**If your Jane loom is one of the first series, it may have a problem that easily can be solved.**

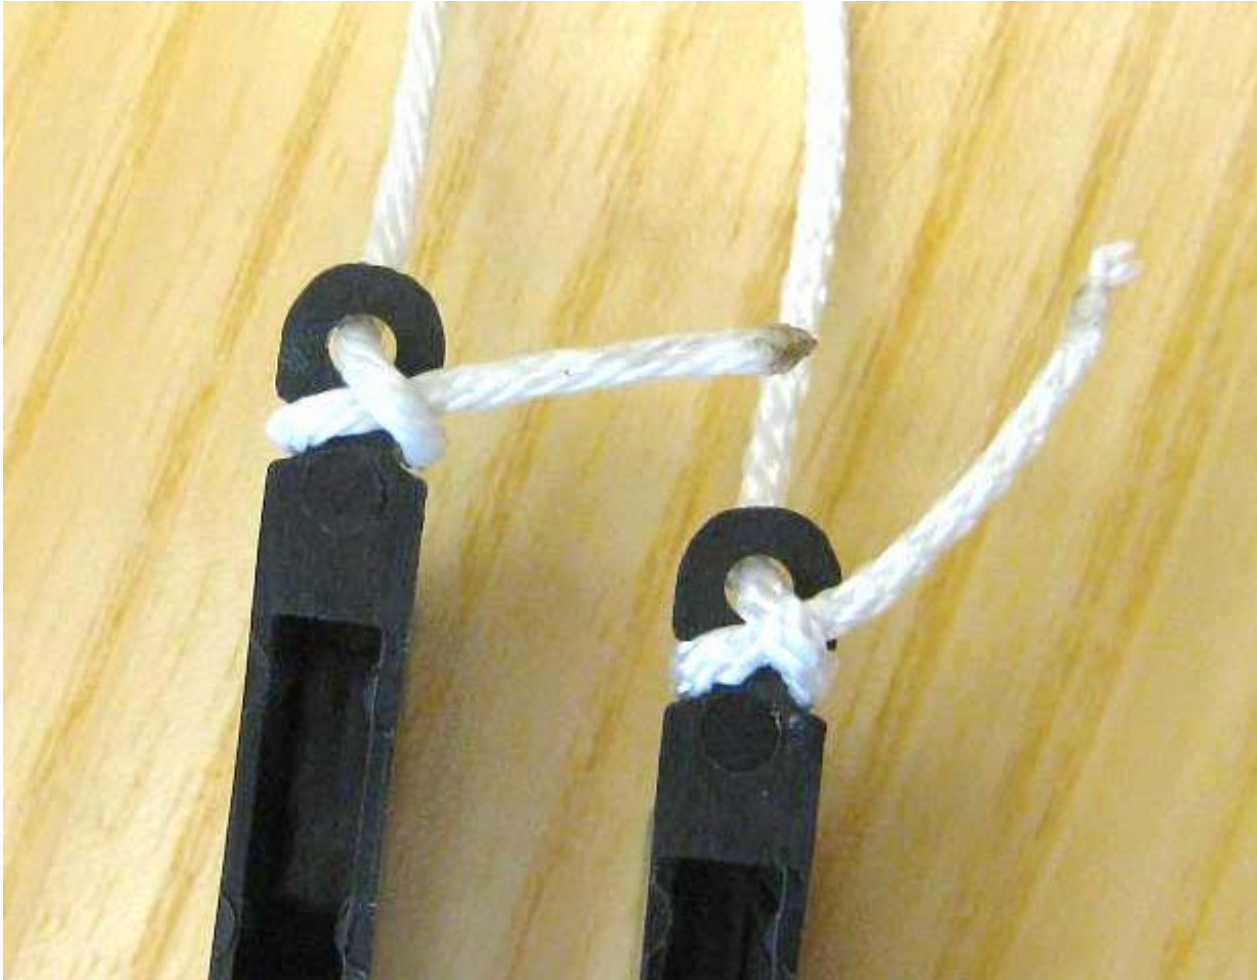
The new shaft side that we use on the Jane has a hole that is a bit slippery if it is connected to the old type of cord that we used on our table looms (left at the picture below). Therefore the knots can go loose.

In the newer series of the Jane we use a different type of cord (right at the picture below) that solves the problem. If you want to replace the cords on your Jane, please let us know if it is a 40 or 70 cm Jane and we'll send you new cords.
